# **SCHOOL DEVELOPMENT STANDARD DEPARTMENT ADVISORY COMMITTEE**

# **QUEEN ANNE ELEMENTARY SCHOOL DESIGN DEPARTMENT RECOMMENDATIONS**

**Project #3026198**

**AUGUST 21, 2017**

**Exhibit 3 Proposed Lot Coverage**

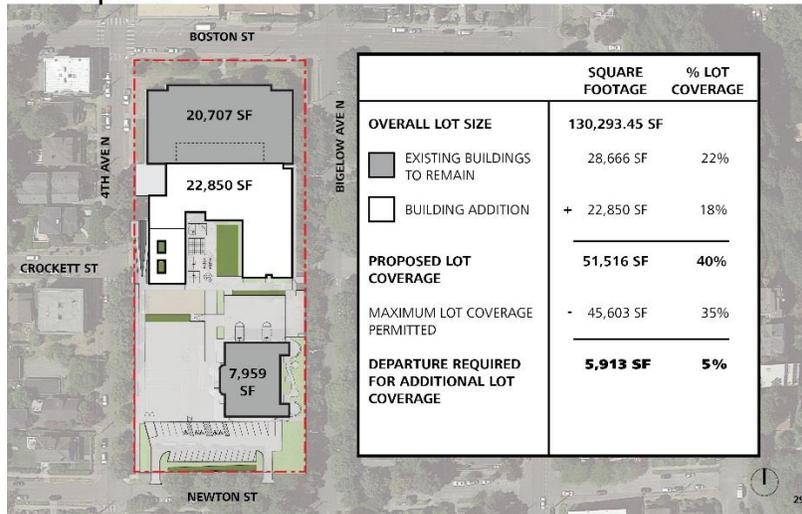
The design team explored locating the gym immediately south of the existing lunchroom rather than expanding the lunch room, reducing a need for additional lot coverage, but due an existing boiler room below the current covered play space if the lunchroom were located above the boiler room, it would need to be modified or upgraded. Locating the gymnasium at the proposed location is the most efficient and cost effective. The committee considered ways to reduce the lot coverage to allow additional parking, but the need for usable play space and adjacency of school functions were a priority. Of the 5% requested departure, 2.5% is covered play space, and the committee agreed this was a reasonable request.

**Recommendation 1 – That the departure to allow greater than allowed lot coverage be GRANTED as requested by Seattle Public Schools without modifications and without conditions.**

**Exhibit 4 Impact of Code Required On-Site Parking Stalls**

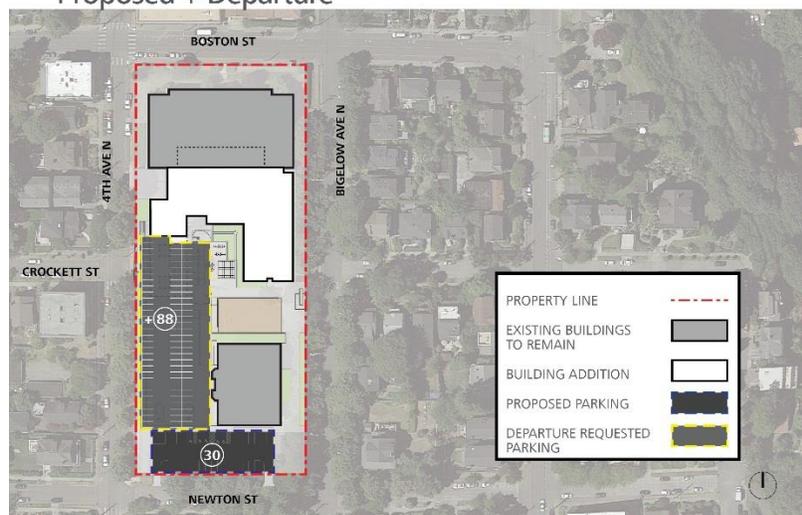
The committee grappled with the public comment they received on the impacts of parent drop-off/pick-up and parking and staff parking, sometimes illegally, on the street in front of homes, as well as a need for play space for students. At the second meeting, the design team presented a chart showing the student enrollment, staff, site area, and number of on-site parking spaces for schools in the area. Queen Anne has a comparatively high number of parking stalls for its site size. The committee noted it did not consider the context of those neighborhoods, i.e. accessibility to additional parking opportunities in the neighborhood. The value of each parking spot was very important to the committee, therefore they requested a scheme where open play space could be used for parking during large after school events that would alleviate parking in the neighborhood when it is at its highest demand.

**Recommendation 2 – That the departure to reduce the parking requirement be GRANTED as requested by the Seattle Public Schools without modifications and with the following conditions:**

- a. Use of play space as overflow parking for large after-hours school sponsored events where the play space is not utilized.
- b. The school must create an enhanced Transportation Management Plan (TMP) and incorporate the following:

1. A designated parent drop-off and pick up along the southeast side 4th Ave N or Bigelow Ave N (depending on where bus loading/unloading takes place) and/or in the south parking lot, with the desire for the drop-off/pick-up be a valet-type of system that would be administered by SPS and volunteers, with SPS analysis and SDOT approval. If the south parking lot were to be recommended as a parent valet drop-off/pick-up, SDOT would like SPS to ensure that two volunteers be located at the entrance and exit of the parking lot, ensuring safety for people walking and biking along Newton St.

2. A rigorous staff parking management component to minimize school-day parking impacts to neighbors nearest the school where teachers and staff who cannot park in the south parking lot park at least one block away from the school, (beyond Lynn St, Nob Hill Ave N, Howe St, and 5th Ave N) and provide resources to educate the school community and enforce the plan.

- c. Allowance for a departure from the required ratio of large to compact stall sizes to increase the number of parking stalls available to staff.
- d. Optimize the number of parking stalls in the south parking lot, with a minimum of 30 parking stalls.
- e. A minimum of 3 ADA parking stalls, with 2 flexible ADA parking stalls, to be converted to and from ADA as necessary, to increase the number of parking stalls available to staff.
- f. Plan for future expansion of bike racks to not limit the number of students that can bike to school in the future.

**Exhibit 5 Location of Off-site Bus Loading & Unloading on Bigelow Ave N.**

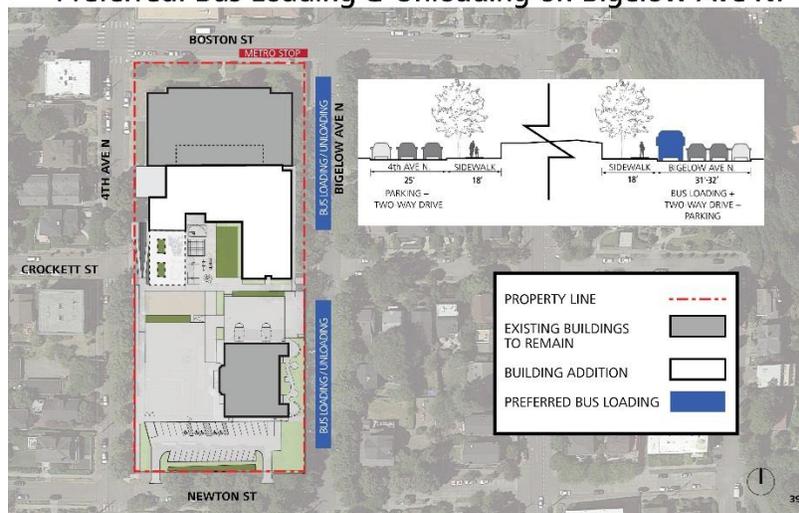
Bigelow Ave N. is the best option available for bus loading and unloading. Boston Ave is unsafe for bus loading and unloading due to sightlines and does not provide adequate space in front of the school for the necessary number of buses, and Newton St is functionally incompatible. Bigelow Ave N is the District's preferred option. Traffic around the school is challenging, and the committee is supportive separating bus traffic from any designated parent drop off and pick up due to safety concerns. Parking in the neighborhood is highly coveted, and any further loss of parking would be a hardship on the neighborhood, as heard during public comment. The Bigelow Ave N. option does not remove any additional parking and it is wide enough for a bus to park as well as two-way traffic and street parking in the east side of the street. Additional suggestions were made to alleviate parking strains on the neighbors, provide safer routes for students to walk/bike to school, and for buses to minimize their presence in the neighborhood.

**Recommendation 3 – That the departure to allow additional bus loading and unloading on Bigelow Ave N. be GRANTED as requested by the Seattle Public Schools without modifications and with the following conditions:**

- a. The school must create an enhanced Transportation Management Plan (TMP) and incorporate the following:
  1. A designated parent drop-off and pick-up along the southeast side 4th Ave N and/or in the south parking lot, with the desire for the drop-off/pick-up be a valet-type of system that would be administered by SPS and volunteers, with SPS analysis and SDOT approval. If the south parking lot were to be recommended as a parent valet drop-off/pick-up, SDOT would like SPS to ensure that two volunteers be located at the entrance and exit of the parking lot, ensuring safety for people walking and biking along Newton St.

2. Strategies to keep buses on arterial streets to minimize bus traffic on Newton St. and prevent bus traffic through adjacent neighborhood streets.
  3. Minimize bus traffic on Newton St. and non-arterial streets, in a manner that parent and bus traffic are separated.

- b. Prohibit school buses from idling while waiting for students to unload and load, and modify bus loading protocol to minimize time spent idling.
- c. The school district must evaluate the utilization of buses to find ways to reduce the number of buses going to and from the school.

- d. Evaluate locating a 4-way stop at 4th Ave N and Boston St. and at Newton and Boston St. with SPS analysis and SDOT approval.
- e. Evaluate establishing a crosswalk at Boston St. and Bigelow Ave N. to encourage safe travel across Boston St. with SPS analysis and SDOT approval.

**Exhibit 6 Location of Off-site Bus Loading & Unloading on 4th Ave N.**

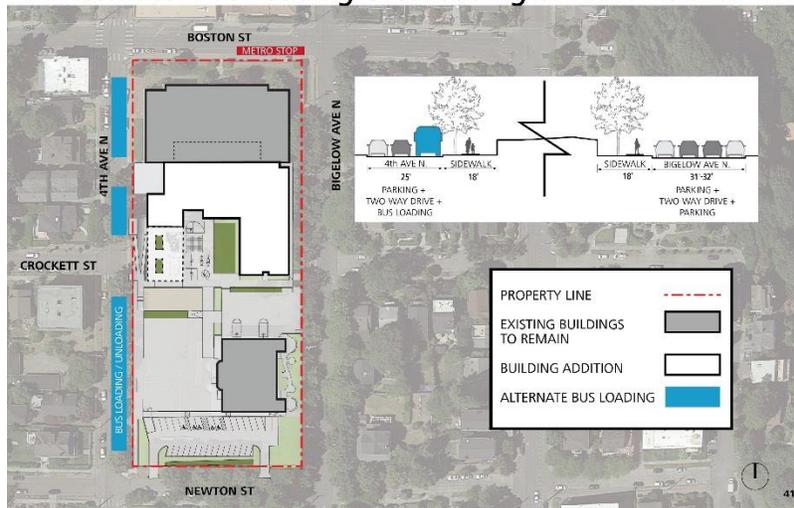
The committee wanted to outright reject this departure. With that said, they understood that SPR has final say if Bigelow Ave N can be used for bus loading and unloading, and if it must happen on 4<sup>th</sup> Ave N the committee wanted to make sure there were conditions put on the use. The biggest concerns were: loss of parking on the west side of 4<sup>th</sup> Ave N due to the narrow width of the street and blocking the emergency route on 4<sup>th</sup> Ave N. Regardless, vehicle activity will need to happen on Bigelow Ave N since parent drop off and pick up should be physically separated from bus load and unload. If bus functions can stay on Bigelow, 4<sup>th</sup> is much better suited for cars dropping off and picking up than buses. There are opportunities for improved circulation around the school and suggestions were made to alleviate parking strains on the neighbors, provide safer routes for students to walk/bike to school, and for buses to minimize their presence in the neighborhood.

**Recommendation 3.b – That the departure to allow additional bus loading and unloading on 4<sup>th</sup> Ave N. be REJECTED as requested by the Seattle Public Schools:**

- a. The school must create an enhanced Transportation Management Plan (TMP) and incorporate the following:
  1. A designated parent drop-off and pick-up along the southeast side Bigelow Ave N and/or in the south parking lot, with the desire for the drop-off/pick-up be a valet-type of system that would be administered by SPS and volunteers, with SPS analysis and SDOT approval. If the south parking lot were to be recommended as a parent valet drop-off/pick-up, SDOT would like SPS to ensure that two volunteers be located at the entrance and exit of the parking lot, ensuring safety for people walking and biking along Newton St.
  2. Strategies to keep buses on arterial streets to minimize bus traffic on Newton St. and prevent bus traffic through adjacent neighborhood streets.

- f. Any solution to use 4th Ave N for bus loading and unloading should maintain parking along the west side of 4th Ave N.
